# 802.1ap: Alternate Internal LAN Proposal

Ken Young  
Jan 31, 2008  
Version 1

# Comment #108

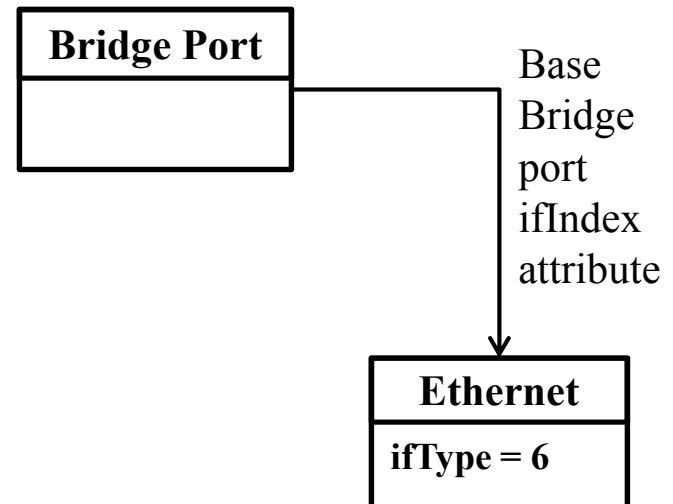
- Comment #108 requested that all bridge ports be associated with a ifTable entry of type 209
- This comment was rejected since this infers a specific ifTable implementation.
  - For example, some ifTable implementations may only model physical Ethernet interfaces
- By rejecting this comment, both options below are possible

# Current Internal LAN Proposal

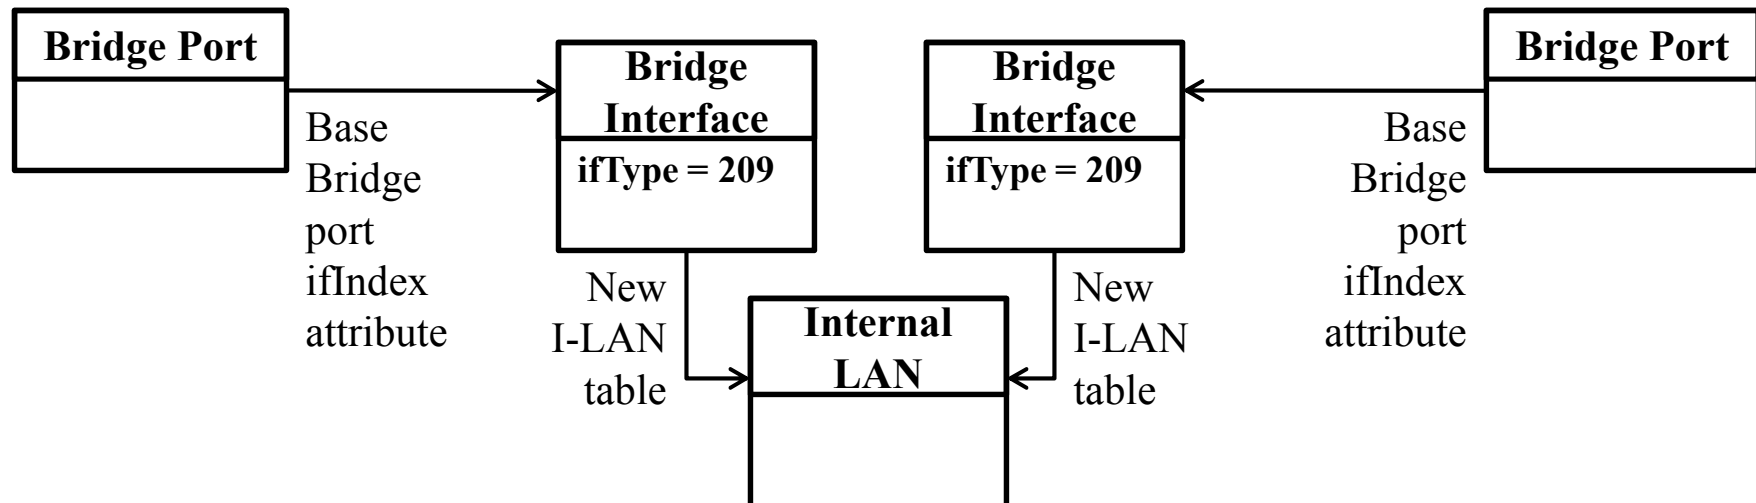
- Can be found here:
  - <http://www.ieee802.org/1/files/public/docs2008/ap-knolish-internallan-0108-v01.pdf>
- In summary, the bridge port's associated interface is related to an internal LAN which is implicitly created.
- The assumptions specified on Slide 5 assume that each port has a unique ifIndex
  - Not required for option 2 on the previous slide! → violates resolution of comment #108

# Alternate Internal LAN Proposal (cont)

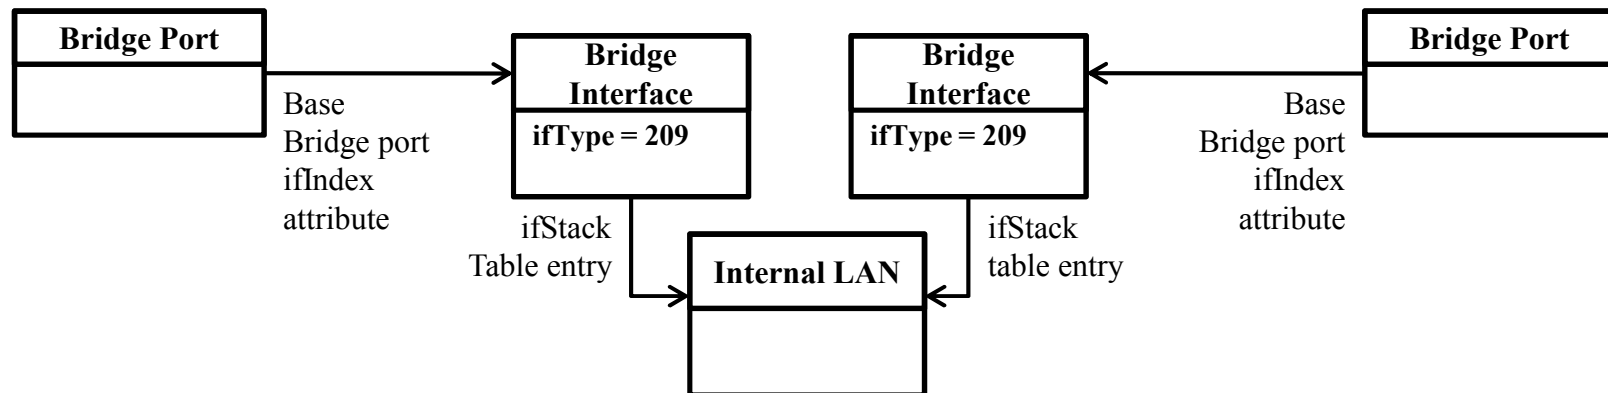
- Instead of assuming that every bridge port has a unique ifIndex associated with it, model the internal LAN as an interface.
- This way, a bridge port can be associated with
  - an Internal LAN directly
  - a bridge interface the stacked on a Internal LAN
- No restrictions are placed on how the system models its interfaces.

*Both options of ifTable are supported!*
